Model	N810	Volt/Hz	Date of Modification	Serial Number
Modified Article	Parts Catalog			
Reason for Modification	Parts catalog correction

MODIFICATION BULLETIN NO. 3

MODIFICATION BULLETIN NO. 5

MODIFICATION BULLETIN NO. 8

Page 26

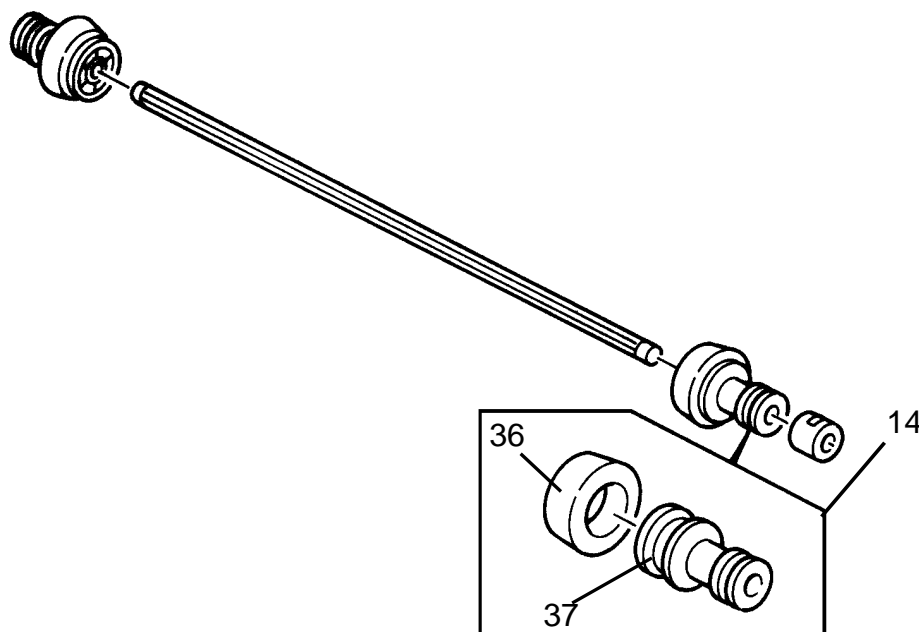
Correct the illustration of item 14 as shown below.

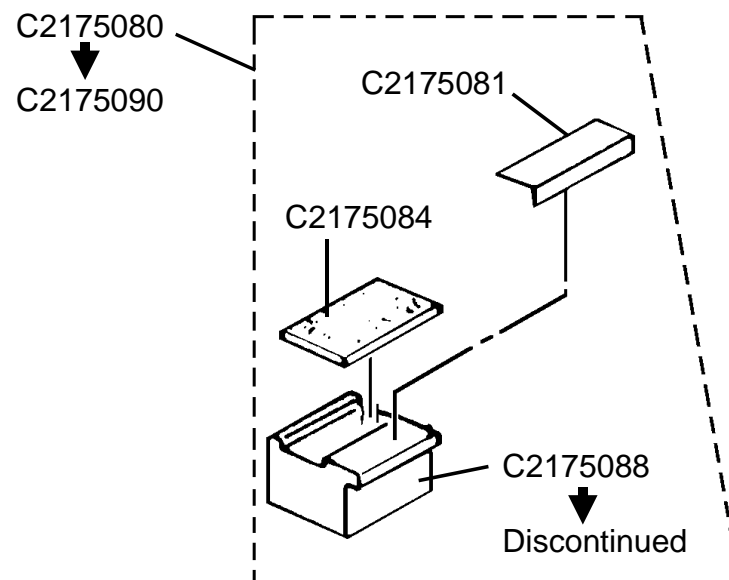
1. To feed paper more smoothly, the friction guide plate (C2175081) has been added from the 2nd production. Due to this modification, the configuration of the friction pad base (C2175088) has been changed. The friction guide plate has already been listed on the parts catalog.
2. To facilitate service, the new friction pad ass'y (# C2175090) including the friction guide plate (index 37, Page 13) has been registered instead of C2175080. The friction pad base is no longer provided as a service part.

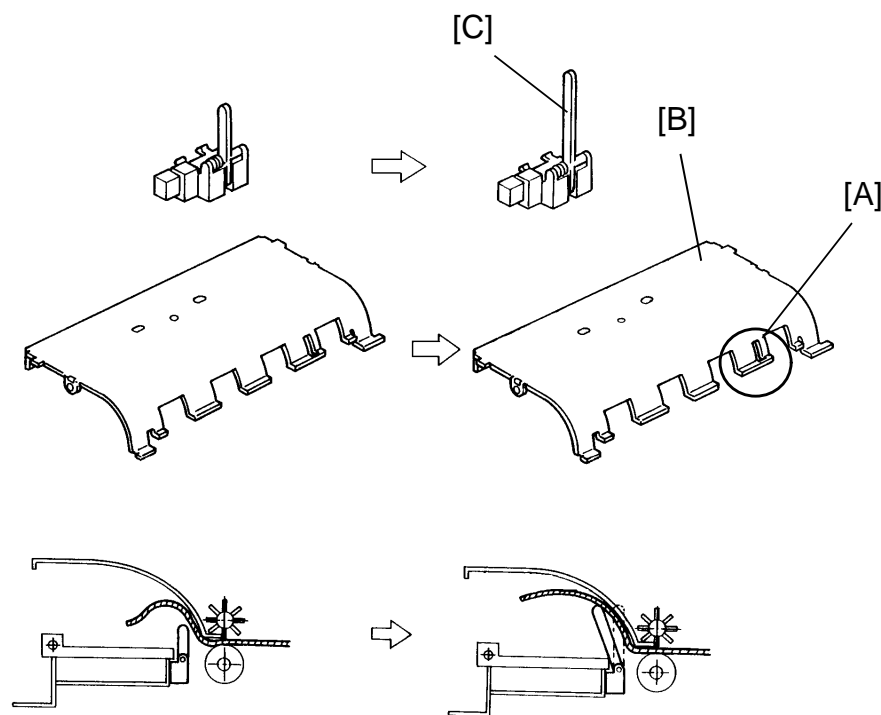
Even if the eject master is transported properly, it is possible that the master eject sensor will not detect the master when the master is transported over the sensor actuator.

To prevent this, a cutout [A] is added to the guide plate - exit unit [B], and the length of the sensor actuator [C] has been increased so that the sensor never fails to detect the eject master.

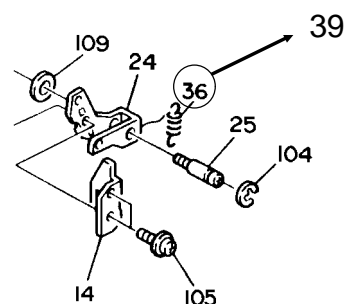
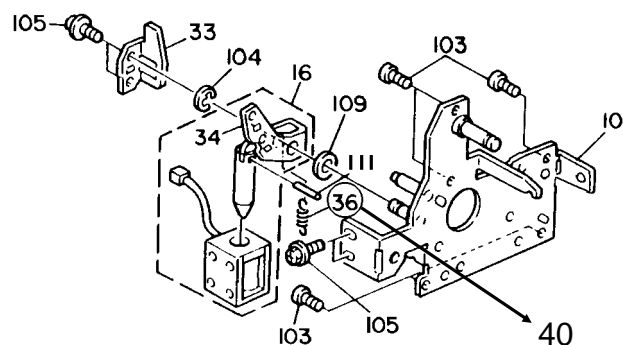
2. Correct the index number 36 of page 30 as shown below.

Delete the following item:

Part Number	Description	Q'ty	Index No.	Page
55066549	Spring Etching Clutch	2	36	31

Add the following items:

Part Number	Description	Q'ty	Index No.	Page
C2175530	Pressure Release Spring	1	* 39	31
55076144	Rink Spring	1	* 40	31

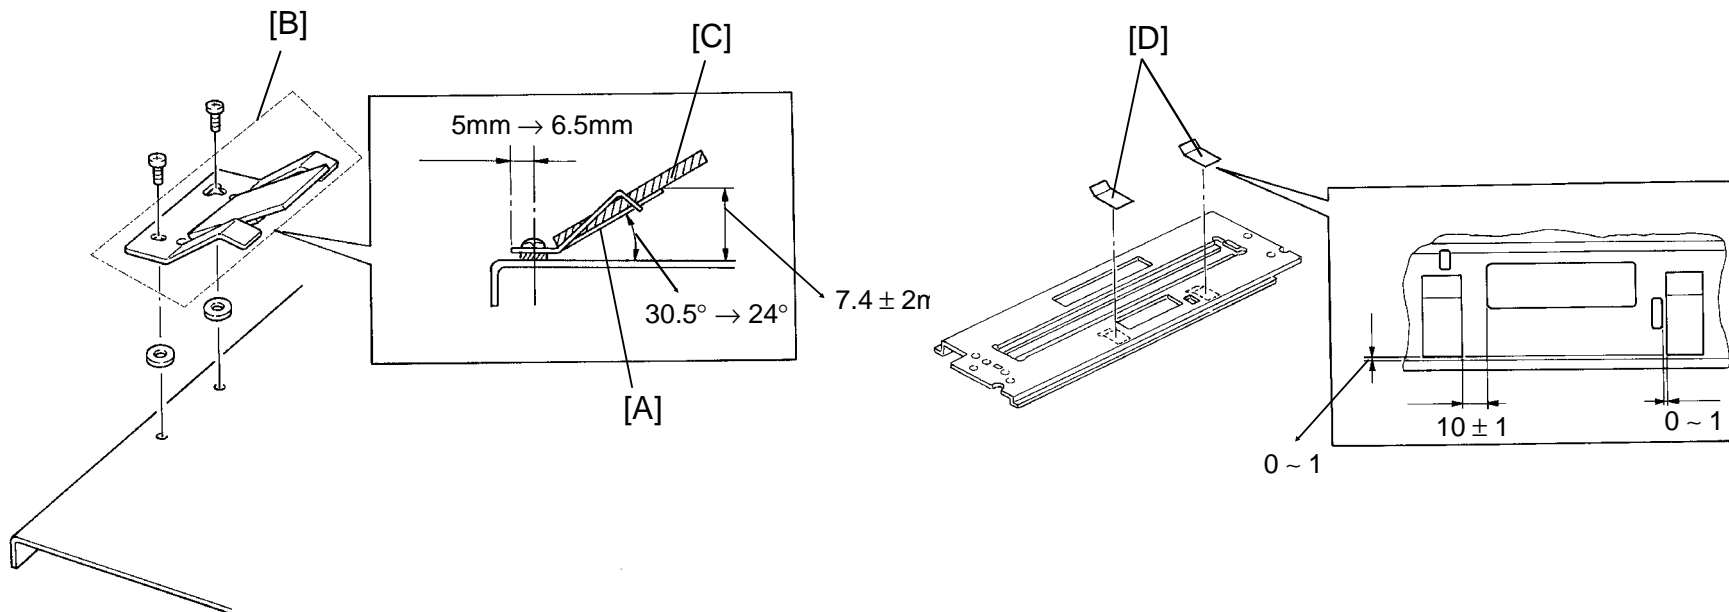
1. To ensure smooth original feed, the angle of the separation spring plate [A] has been changed from 30.5° to 24°. Also, the position of the plate [A] has been shifted by changing the screw hole positions.
2. To facilitate service, the ADF friction pad ass'y [B] which includes the ADF friction pad [C] has been registered as a service part instead of the separation spring plate [A].
3. New mylars (original guide mylar, index 19) [D] have been installed on the upper guide plate [D] to prevent double feed. These mylars push the second original up to ensure the original registration sensor can detect a gap between the 1st original trailing edge and 2nd original leading edge. This prevents two original from being fed continuously.

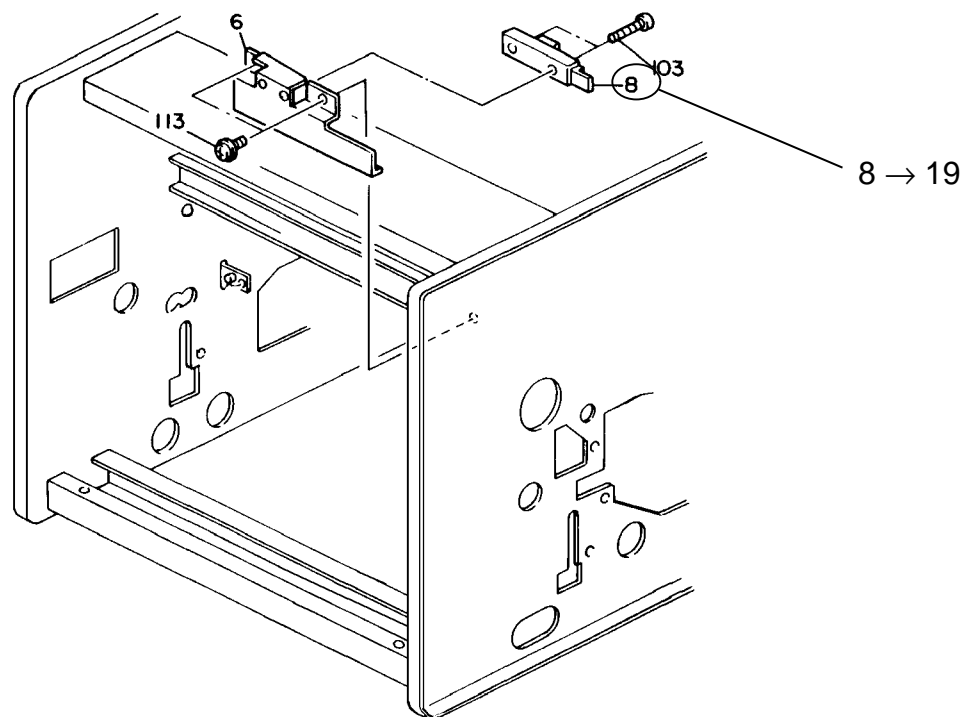
Due to parts standardization, the drum master sensor (index No. 8) has been changed to the one used for the paper exit sensor (index No. 19).

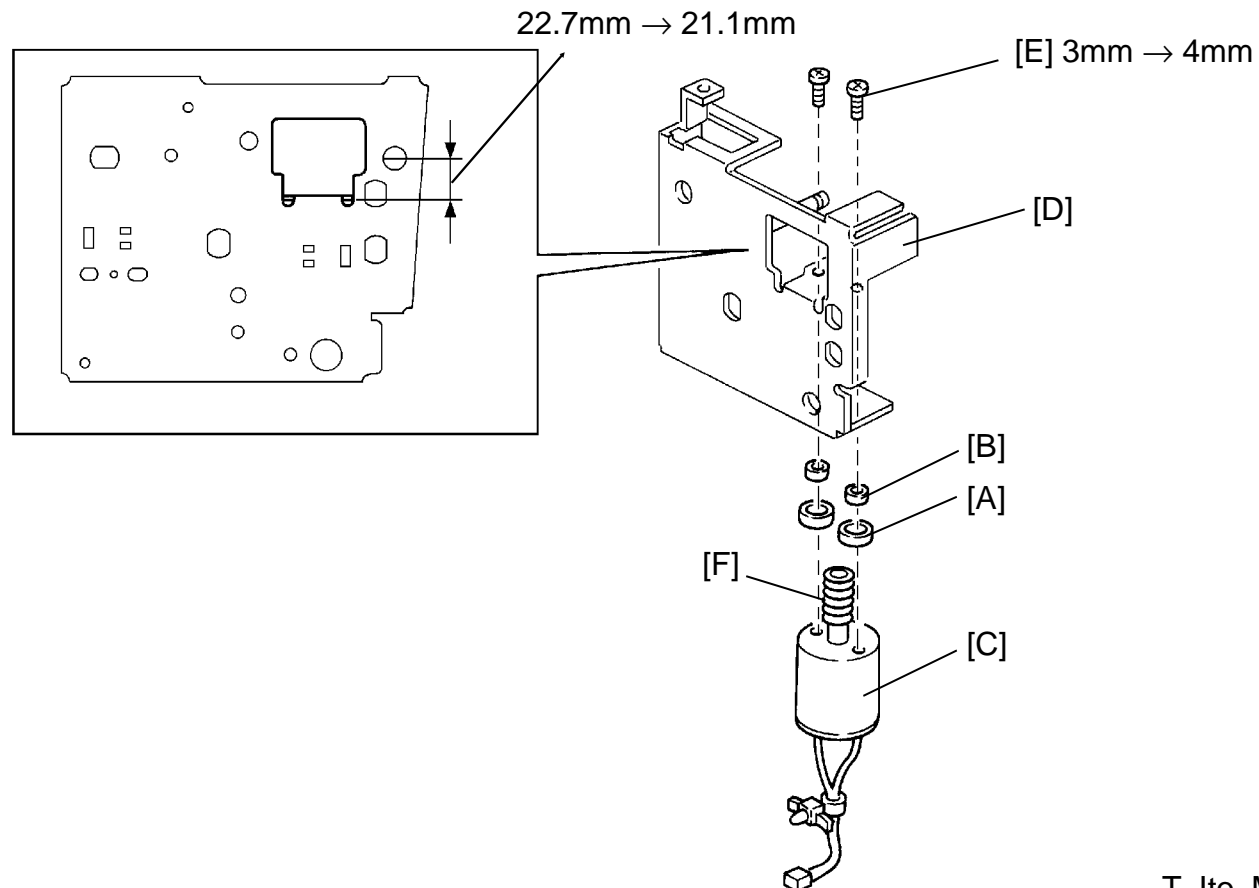
To reduce noise, two insulators [A] and bushings [B] have been inserted between the pressure motor [C] and the right side plate. [D]

Due to this modification, the two screws [E] fixing the motor have been changed from 3mm to 4mm. Also, to keep the relation of the position between the pressure plate gear and the worm gear, [F] the configuration of the right side plate has been changed.

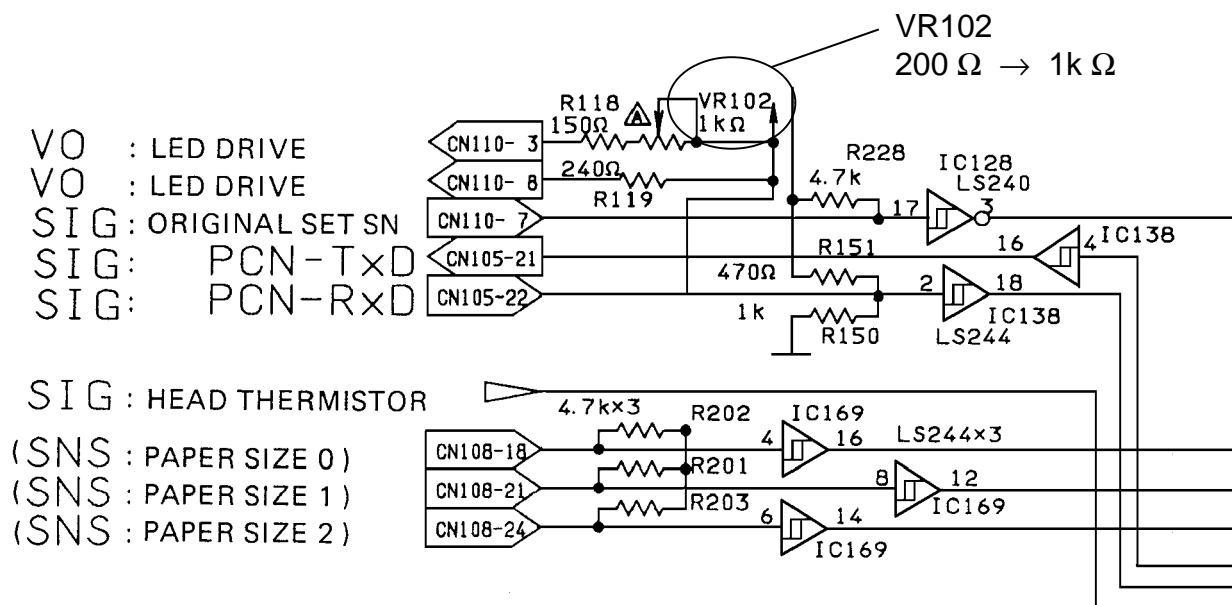
To extend the range of the sensor adjustment, a variable resistor on the main board has been changed from 200 Ω to 1K Ω . The part number of the main PCB remains the same.

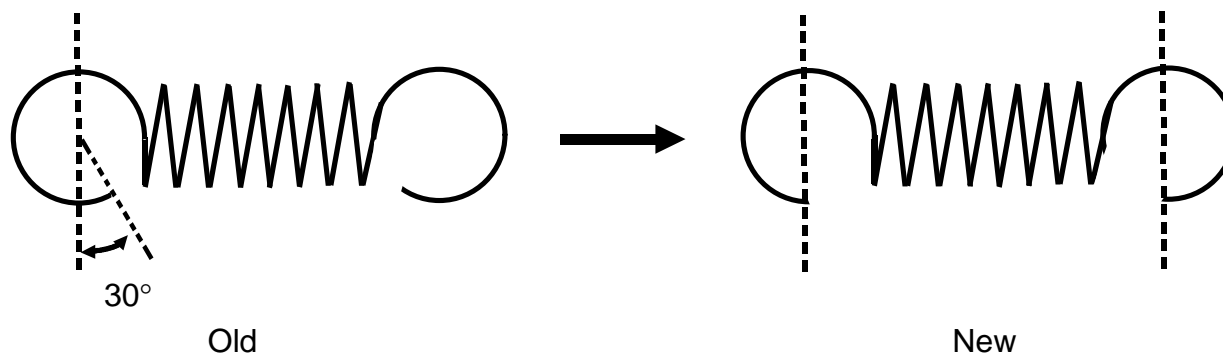
To hook the spring on the pressure plate arm more easily, the configuration of the pressure plate spring has been changed as shown below.

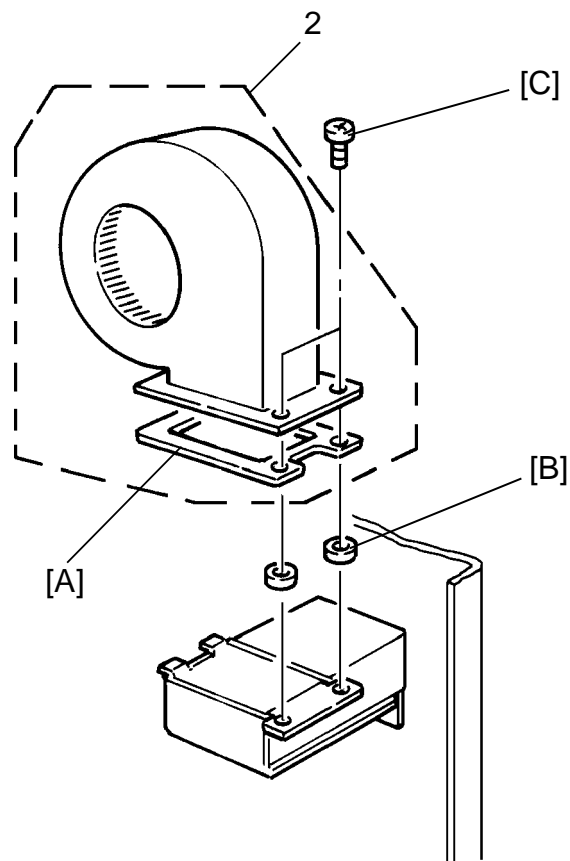
To reduce noise, a rubber base [A] and two bushings [B] have been added to the air knife motor. Due to this modification, the two screws [C] fixing the motor have been changed from 6mm to 8mm.

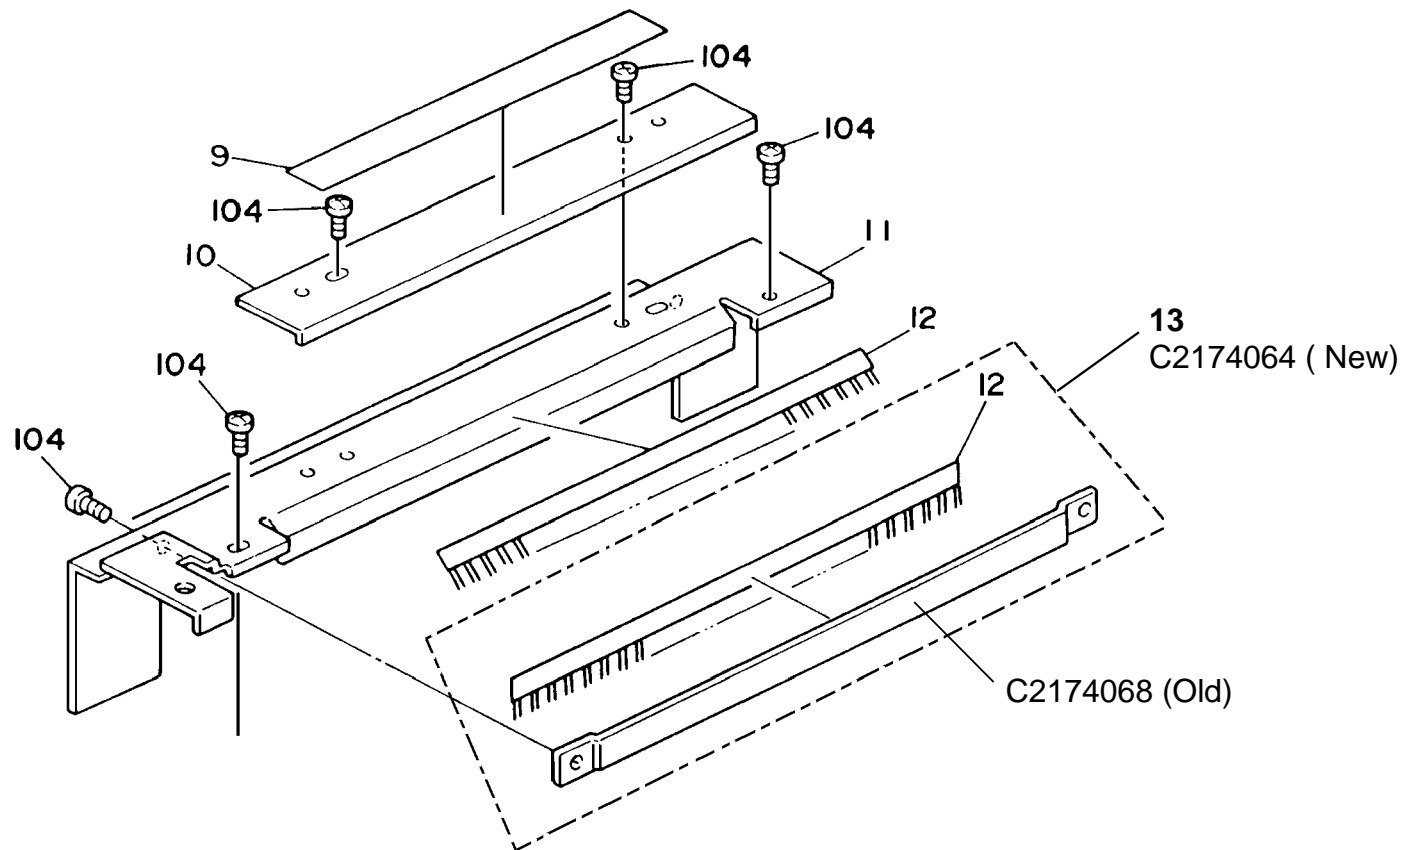
To facilitate service, the Antistatic Brush Ass'y (C2174064) is now provided as a service part instead of the Inner Cover (C2174068), because in the field it is difficult to stick the brush to the correct position of the inner cover.

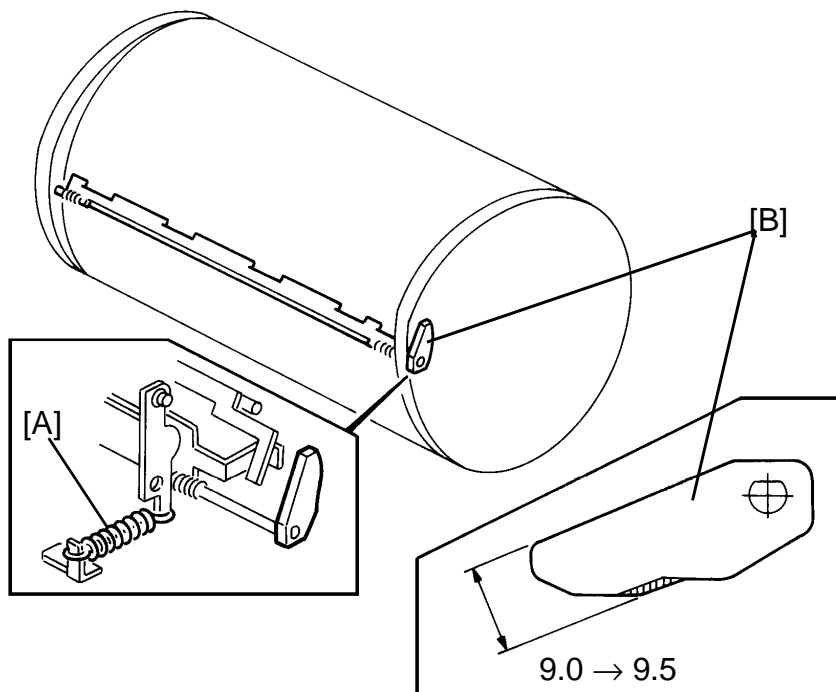
To minimize creasing of the master around the drum, the tension of the two springs that apply tension to the tension roller has been increased. To ensure proper master clamber opening after the tension is increased, the shape of the Clamper Cam [B] has been changed.

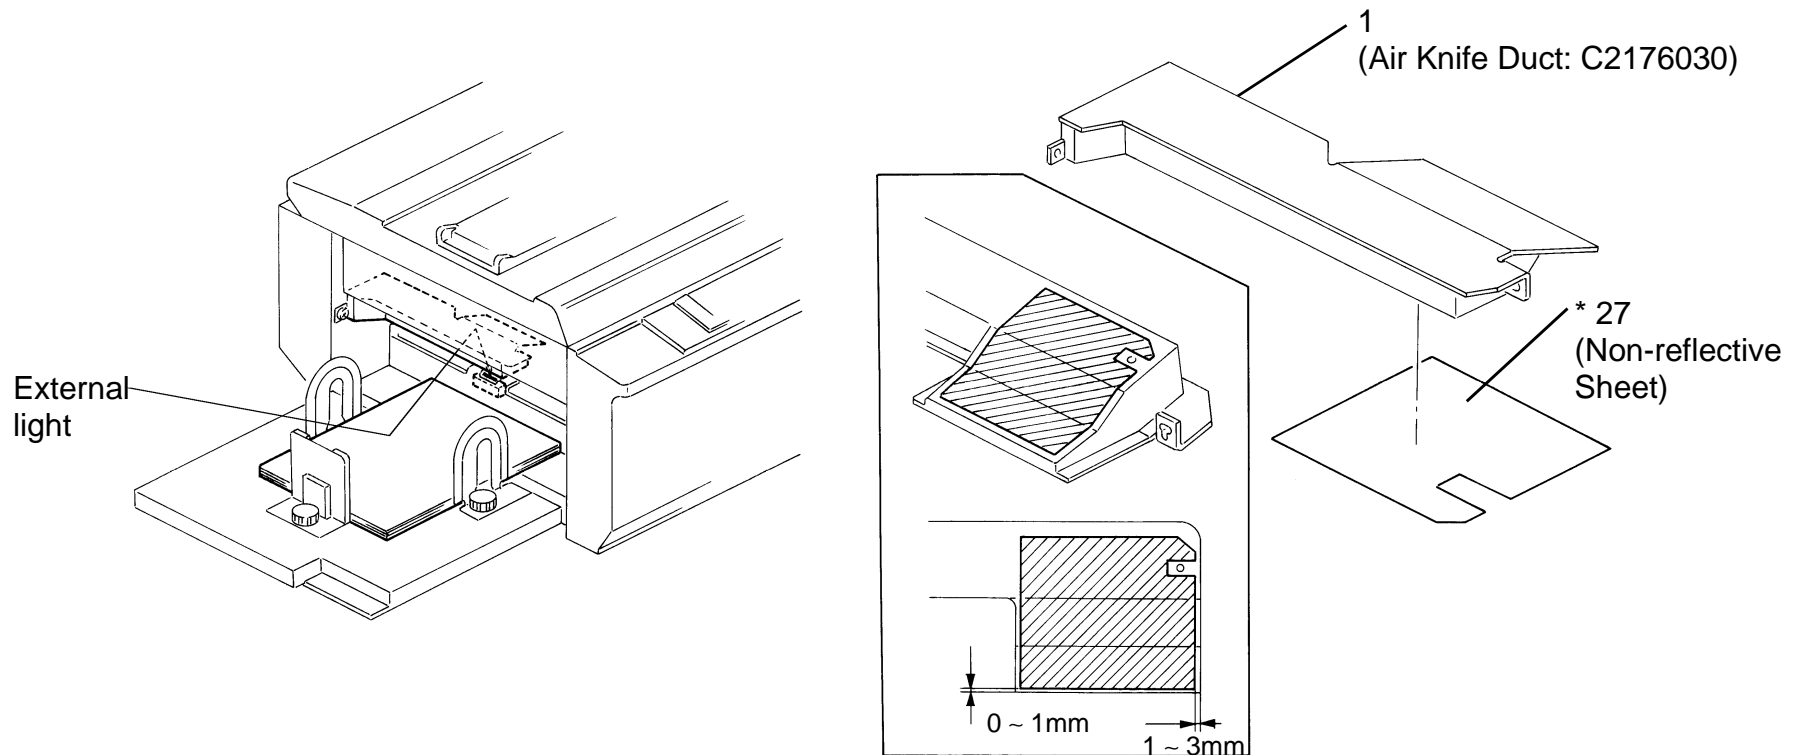
The exit sensor may detect a paper exit jam mistakenly when external light exposes the sensor as shown below. To minimize this, a sheet which has a light non-reflective material has been stuck on the air knife chamber.
